**SUBJECT: ON Semiconductor Final Product/Process Change Notification #16264**

**TITLE:** TSSOP package -bottom marking elimination

**New TSSOP Top Marking Codes (after date code 0916)**

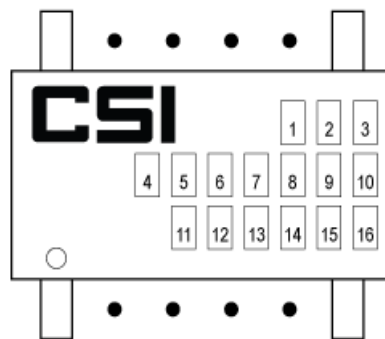
The device marking will be modified to show all information on the top. The bottom mark is to be eliminated.

The position of some marking codes will be altered. A description of the top mark locations is shown beginning on page 2.
